FINAL PHASE I
CONTAMINATION ASSESSMENT REPORT
SITE 36-3: INSECTICIDE PIT
(Version 3.3)

APPENDIX 36-3-C
COMMENTS AND RESPONSES

Re: Rocky Mountain Arsenal (RMA),
Review of Final Phase I CAR Report for
Task 1, Site 36-3 Insecticide Pit

RESPONSES TO ENVIRONMENTAL PROTECTION AGENCY COMMENTS
ON THE FINAL TASK 1 REPORT
SITE 36-3: INSECTICIDE PIT

Figure 36-3-6
 PHASE I INVESTIGATION,
 BORING LOCATION MAP,
 SITE 36-3

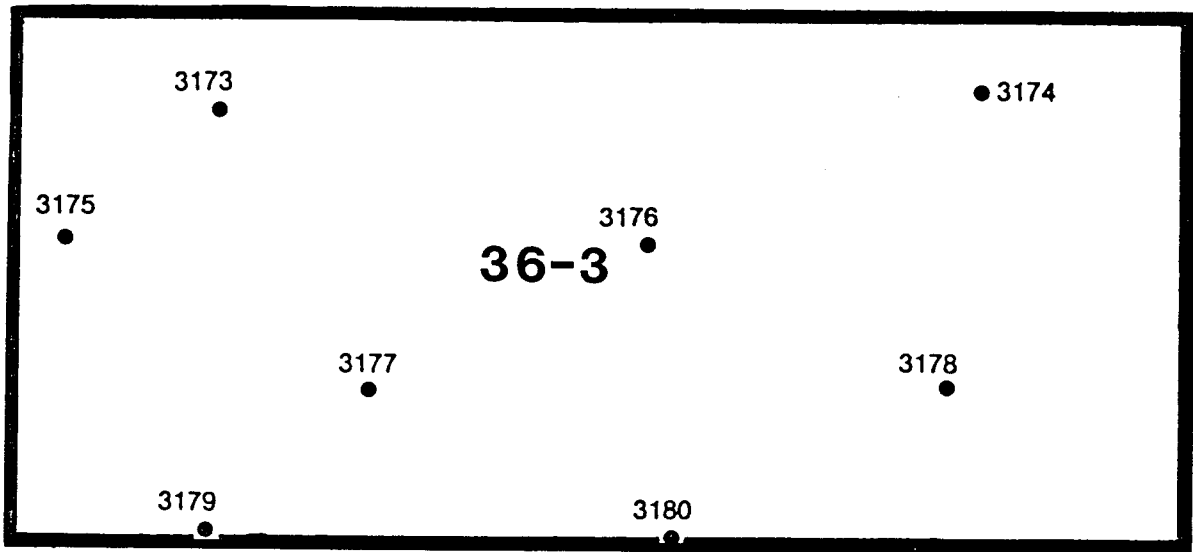
Figure 36.3-6 [sic] should show the location of trenches based on aerial photos.

The trench locations were not placed on the figure due to the complex nature of the site which made such a presentation confusing and potentially misleading. The geophysical investigation generally detected high response levels and intense anomalies, such that it was very difficult to delineate trench and intertrench material. Maps presented in the geophysical report display these results, and explain that no direct correlation between trenches indicated on aerial photographs and geophysical anomalies was possible due to these uncertainties. The proposed investigation of suspected trench locations is based on the chemical and geophysical data. Further attempts to map trench locations will be made when additional data is gathered through Phase II borings.

Figure 36-3-7
**PHASE I INVESTIGATION,
 CHEMICAL ANALYSIS
 RESULTS, SITE 36-3**

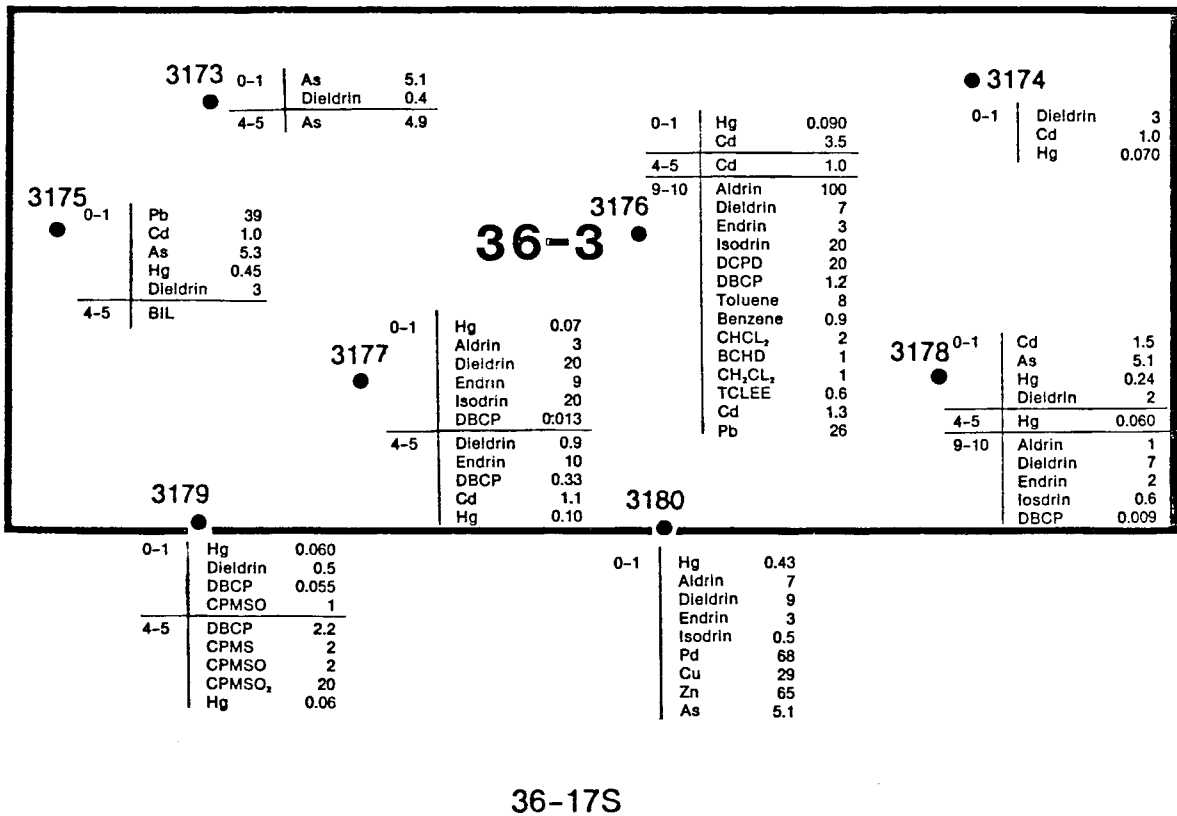
7. P. 36-3-22 Figure 36-3-10 should be corrected to show contaminants at or in excess of the revised indicator levels for metals.
8. P. 36-3-20 Table 36-3-3 should differentiate when samples are not analyzed for a particular class of organic chemicals such as volatiles.

7. 36-3-22 The figure has been revised as requested and now shows values within or above the established indicator ranges.

Figure 36-3-8
 PROPOSED PHASE II INVESTIGATION,
 BORING LOCATION MAP, SITE 36-3
 SOURCE: ESE, 1987

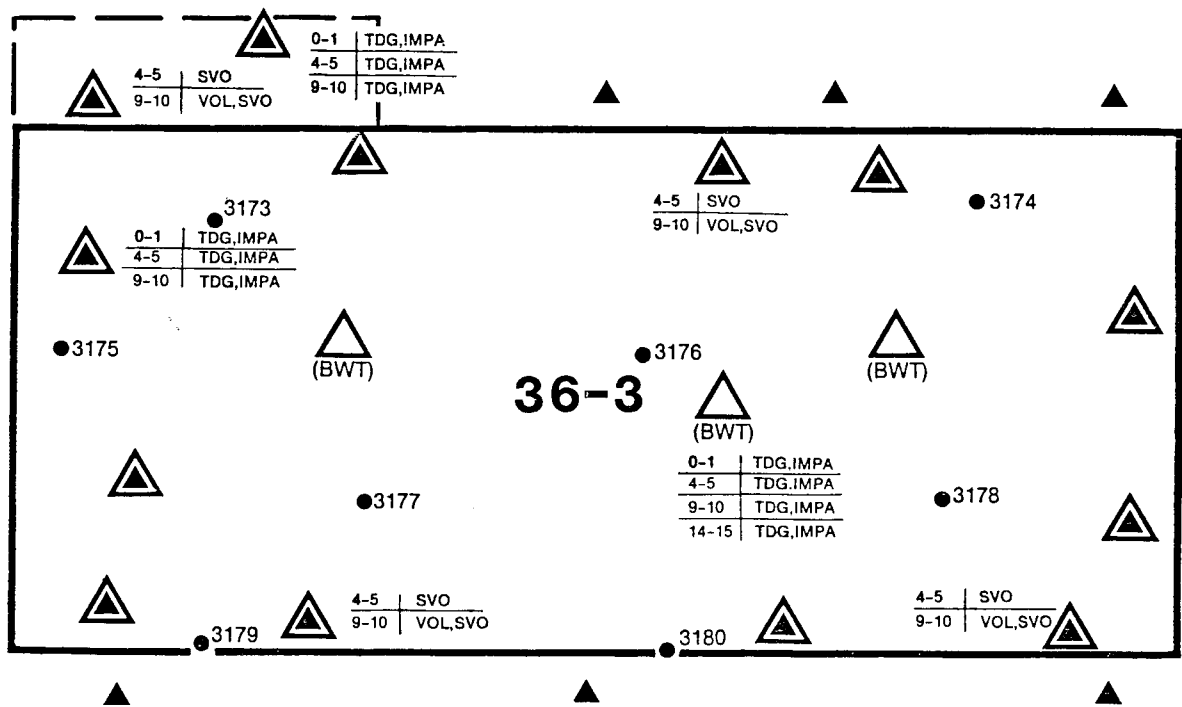
The Phase II survey should be revised to include an evaluation of the metallic anomalies discovered during the Phase I investigation. Containerized wastes could have been disposed of at this site and their presence would effect the remedial action required.

The Phase I geophysical investigation was used to identify potential sites of buried wastes within Site 36-3. Some areas do contain containerized wastes, as drums are observable at the surface. Such information is recorded in field logs. No borings can be placed within these areas for safety reasons, thus the anomalies have been investigated to the extent possible. Evaluation of the metallic and other anomalies will be continued in conjunction with Feasibility Studies.
